AMENDMENTS TO THE DRAWINGS

REMARKS

The present invention, as recited in amended claim 1, is a coreless linear motor that is structured to reduce a magnetic gap between the two rows of left and right armature coils. The structure of the present invention also leads to reduced energy loss and lessening of the temperature rise because of the energy loss. Importantly, the present invention (as recited in claim 1) requires at least one end of the two rows of armature coils in the direction perpendicular to the direction of a magnetic gap between the rows of magnet be branched into two parts. Further, a substrate for connecting the coils is inserted into the gap between the branching parts.

Drawings

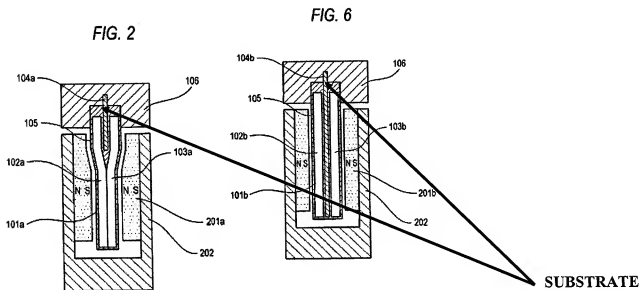
Drawings has been objected to because of various informalities.

The Examiner has objected to the Drawings because of various informalities. We propose submitting revised drawings with Figs. 5 & 6 duly marked "Prior Art" to overcome the noted objections.

The attached sheets of drawings include changes to Fig 5 and Fig. 6. The sheets, which include Fig 5 and Fig. 6, replaces sheet the original including Fig 5 and Fig. 6.

Cross section of the linear motor according to the present invention (as recited in amended claim 1), as well as the admitted prior art of Fig. 6 of the present Specification are reproduced below to illustrate the differences therein.

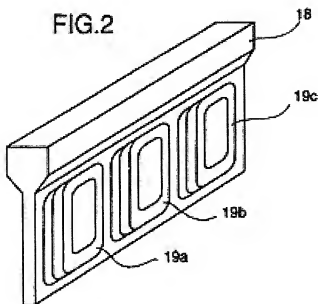
The Examiner admits to the above difference between the admitted prior art and the present invention. However, the Examiner contends that Takedomi overcomes the deficiency noted in the admitted prior art. The Examiner refers to Figs. 1 and 2 of Takedomi. Fig. 2 of Takedomi showing the substrate 18 and the coils 10a-19c is reproduced below.

As is clear from the figure above, the armature coils are not attached and branched at one end into two parts as required by the present invention. The coil frame 18, which the Examiner reads on the substrate of the present invention, stretches all the way from the top portion of the coil to the bottom portion of the coil. In that sense, Takedomi is no different from the admitted prior art of Fig. 6 of the present Specification. The Examiner is believed to be mischaracterizing the structure of Takedomi in alleging that in the above structure, the armature coils 19a-19c branch at least at one end to define a gap in which the substrate 18 is positioned.

For example, in the admitted prior art of Fig. 6, the substrate 104b is positioned all along the longitudinal section in between the armature coils 102b and 103b. On the other hand, in the present invention the substrate 104a is positioned only in the gap that is formed between the branching ends of the armature coils 102a and 103a.
